Service Manual

CD Stereo System

Model No. **SA-AKX74PH**
SA-AKX74PN
SA-AKX94PH
SA-AKX74PR
SA-AKX94PR

Subject : Updates on Block Diagram, Schematic Diagram, Printed Circuit Board, Exploded View & Parts List.

SA-AKX74PH/PN CD INTERFACE / MIC / VOLTAGE SELECTOR CIRCUIT

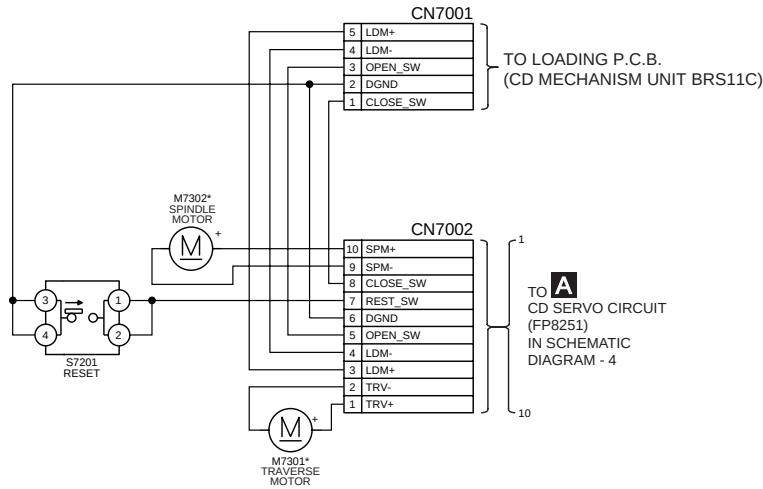
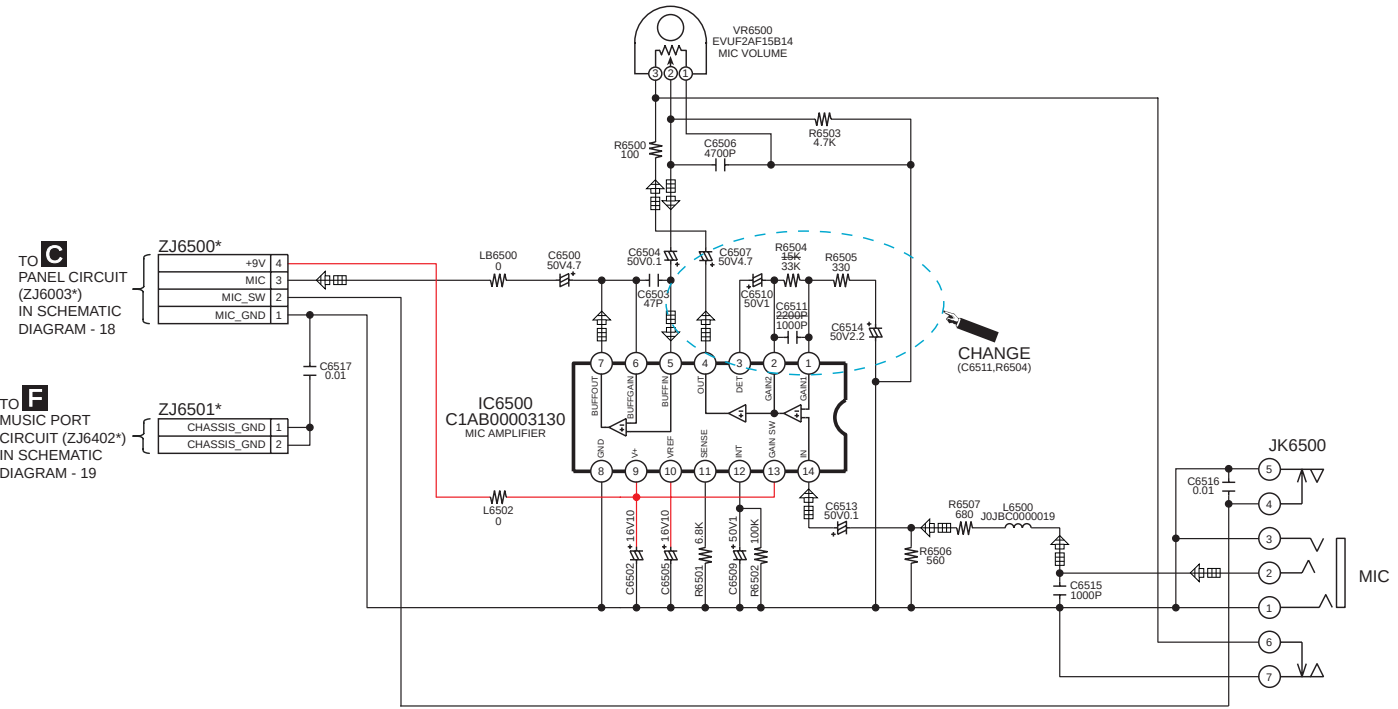
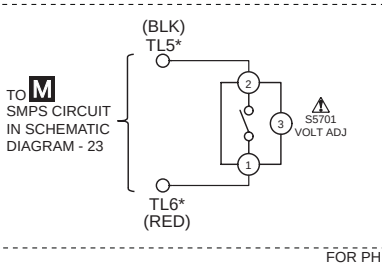
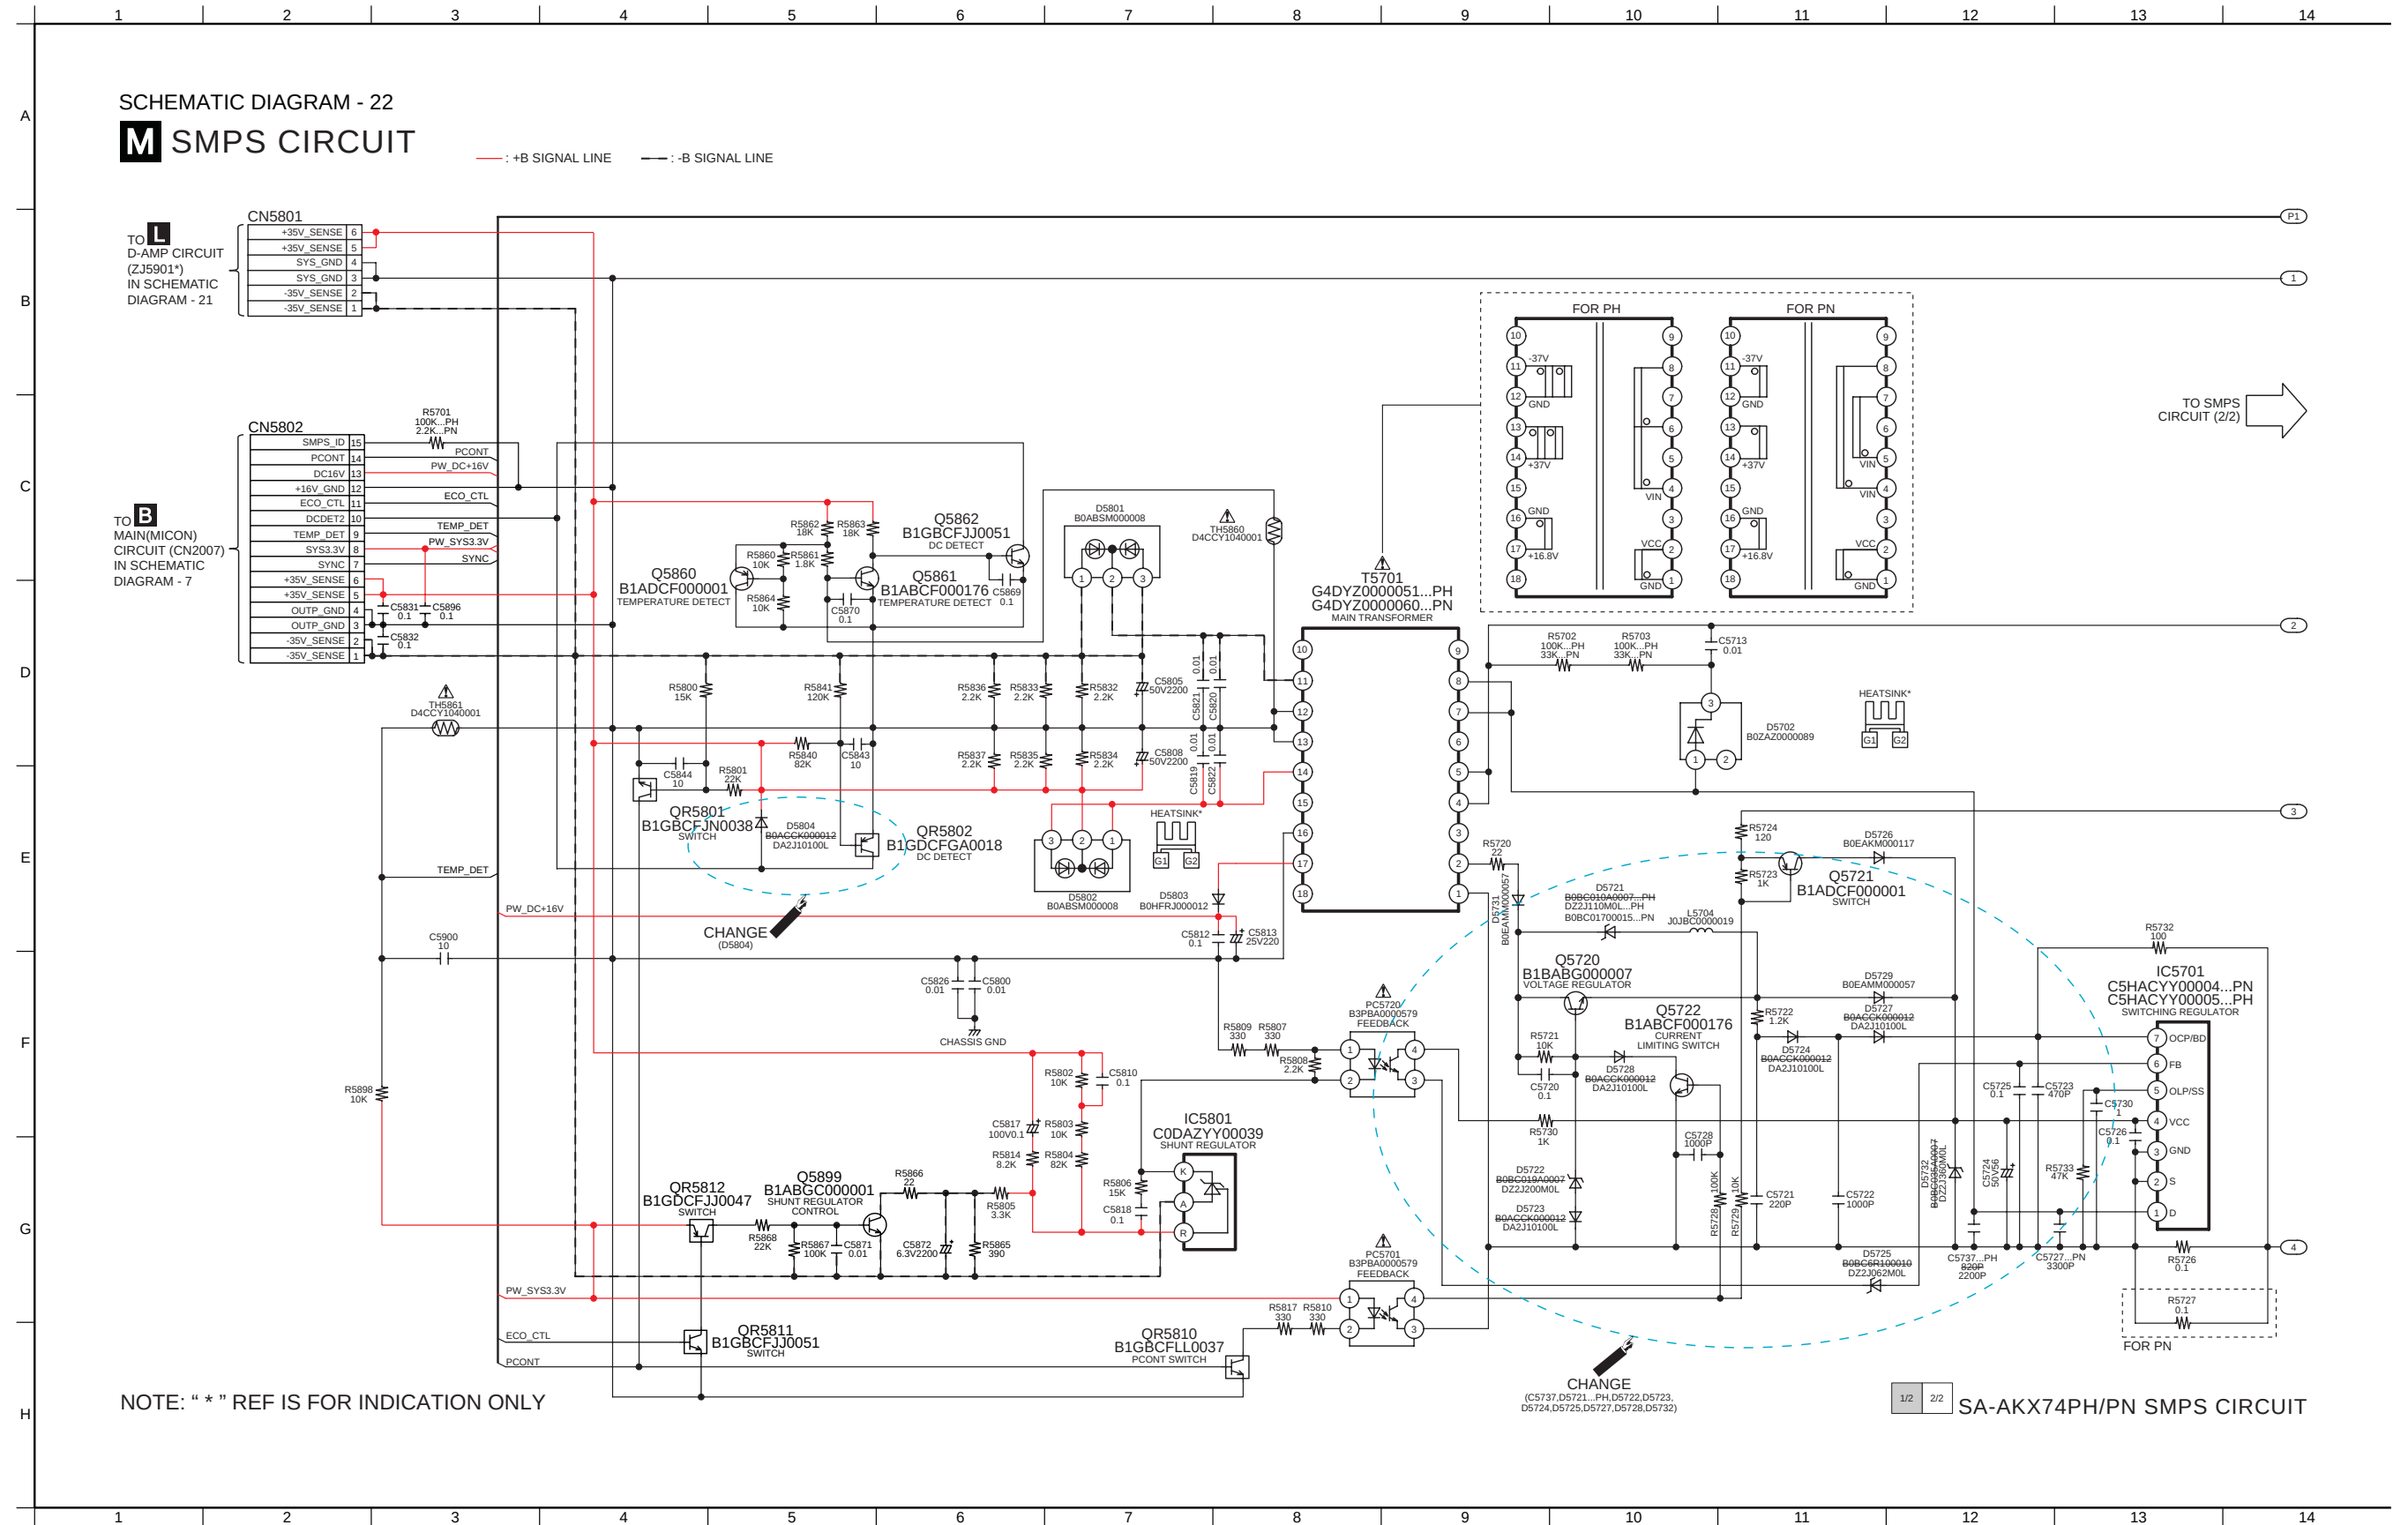
With reference to original service manual (section 16.7) on pages 102.

SA-AKX94PH CD INTERFACE / MIC / VOLTAGE SELECTOR CIRCUIT

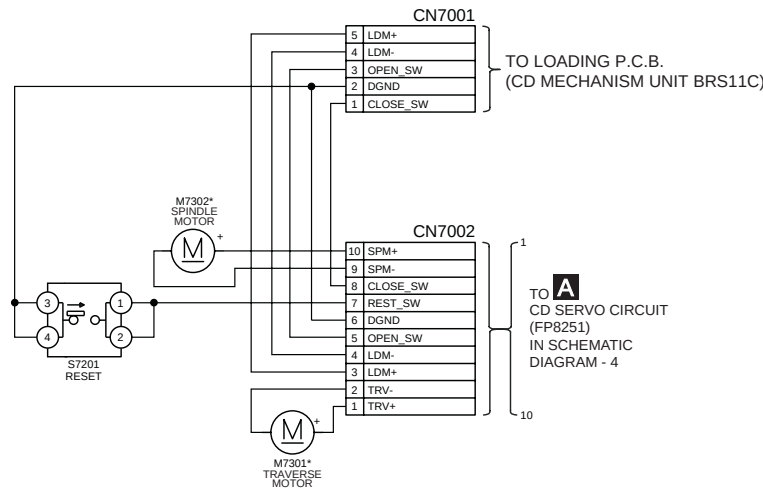
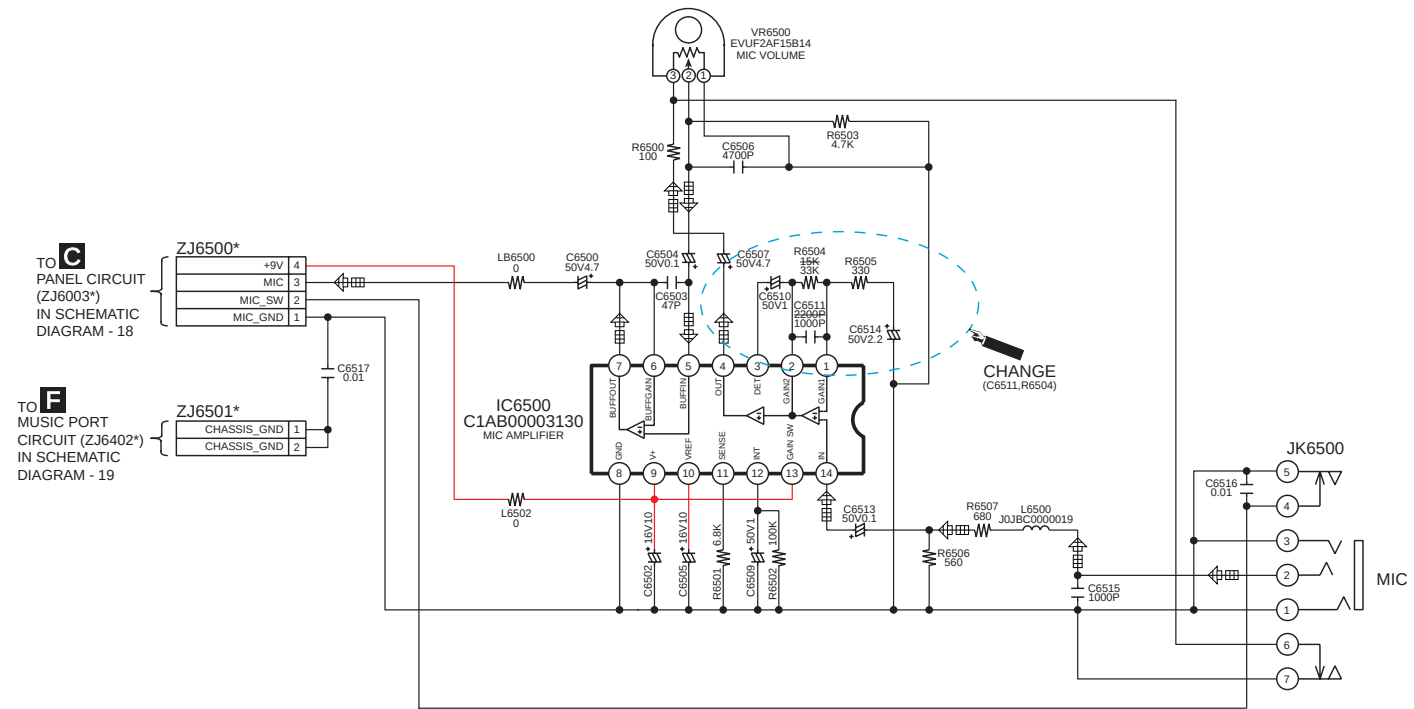
With reference to original service manual (section 16.7) on pages 106.
